RILEY COMMUNITIES

Local Area Planning Project

Phase 2: EXPLORE - What We Heard Report
Fall 2023

Phase 2: EXPLORE Engagement & Communications Summary

Topic 2: Moderate-to Large-Scale Growth

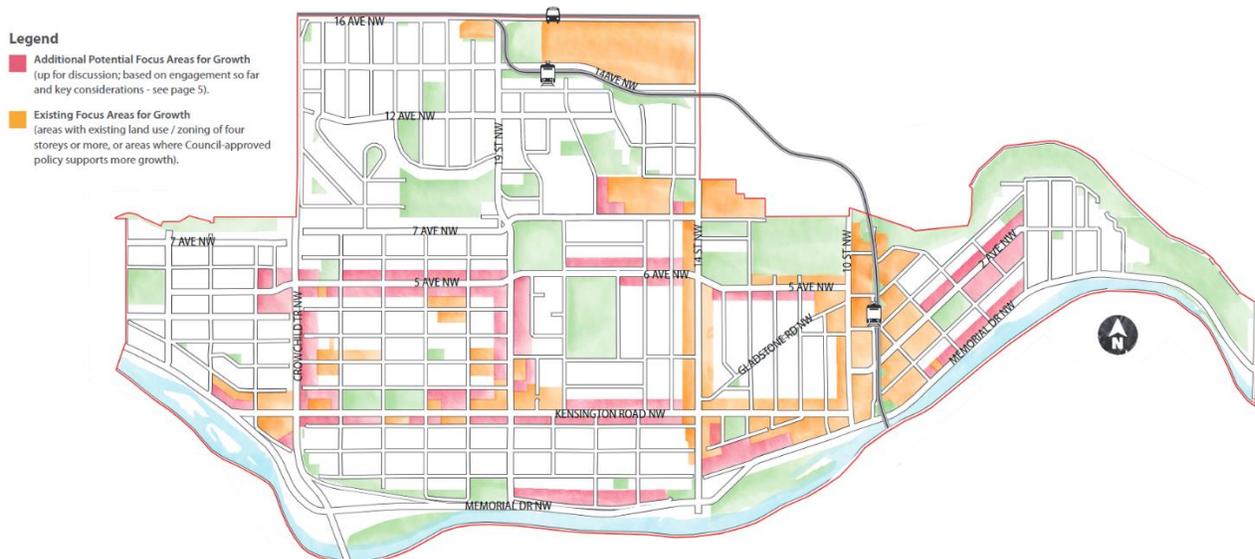
- Participants provided corridor-specific insight, observations and feedback regarding where growth and height should be removed or added.
- The Lions Park Station, North Hill Mall site and neighbourhood of Briar Hill received responses indicating more growth was needed and could be managed in these areas.

- Respondents identified areas for additional growth often connecting responses to amenity proximity.
- General support was a significant theme in response to the Focus Areas for Growth Map.

- Respondents expressed concerns specific to potential building height, and privacy loss and brought forward suggestions around transition zones.
- Comments and questions were received about traffic patterns and mobility impacts in the Riley Area.

Lions Park Station Area

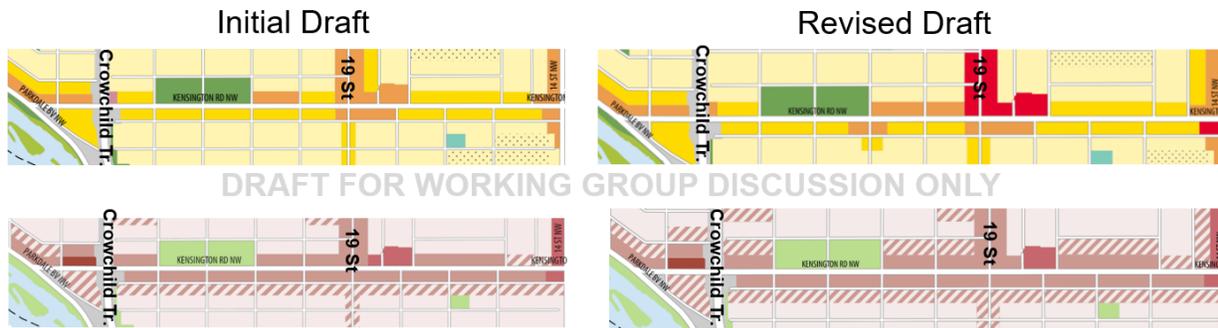
- The working group members supported the changes at North Hill Mall acknowledging this is an appropriate place for intensity and flexibility of site planning. Some would like to see affordable housing integrated.
- Working group members noted green space near Louise Riley Library was smaller in real life than what was reflected in the presented maps.
- The working group discussed how best to activate the edge of Lions Park with grade-oriented units to keep eyes on the park.
- Can LRT stations & TOD/Walk radius on both category and scale map be added to evaluate density in this walkshed more clearly? Land values were considered to be an obstacle to adding intensity in the surrounding area.

More Connector form was added from the May 2023 session, including along Lions Park after receiving additional insight. The commercial strip mall along 19th Street N.W. changed from red to orange to allow for flexibility and commercial uses and to match the existing form. The highest scale was added to the mall site. Appropriate policies to capture scale transitions on this site are still being worked on and requirements will be tied to a comprehensive planning site overlay, which will require further details at the time of submission to ensure scales are achievable and thoughtful in their approach.

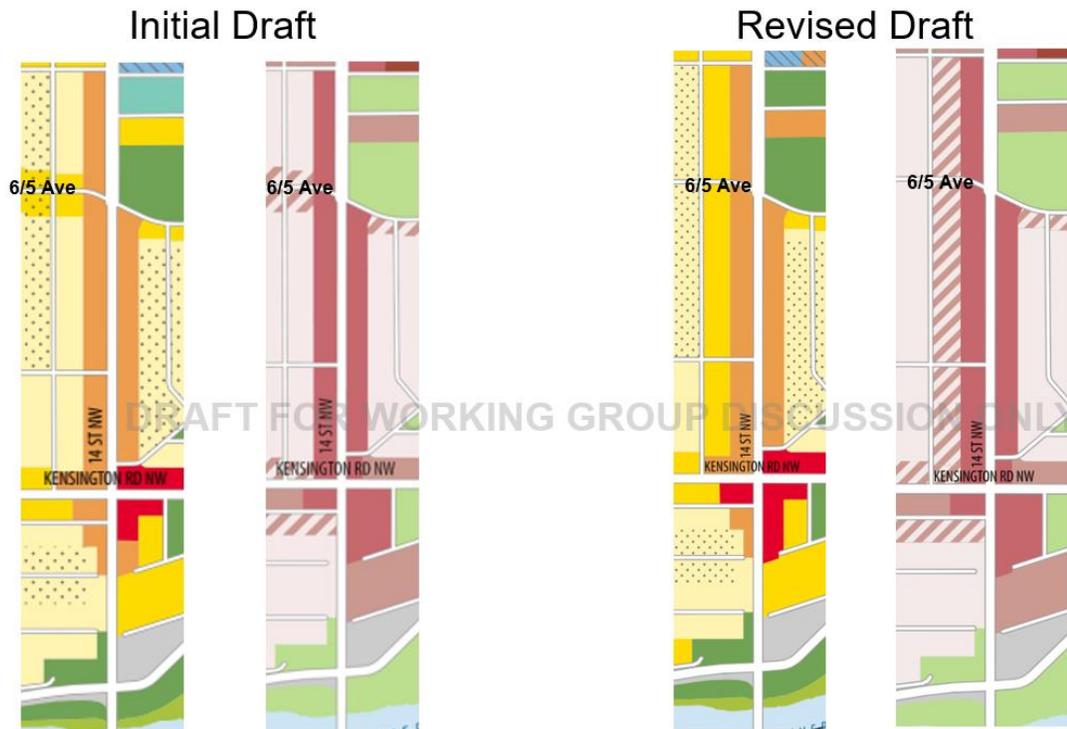
- 19th Street N.W. scale generally makes sense to the working group as a "village-type" area so the mix of flex and commercial makes sense. Some concern was expressed about the interface to the east with four storeys transitioning to limited.

Since the May 2023 draft, the Kensington Road intersection was updated from Neighborhood Flex to Commercial as commercial at-grade will be an important development feature along this "mini main street". East of 19th Street N.W., north of the new Legion building, Neighborhood Connector was changed to Limited due to limited access to 18 A Street cul-de-sac. The strip mall with Demetris' Pizza moved from low scale (six storeys) to Mid-Scale (12 storeys) to integrate with the new Legion building.
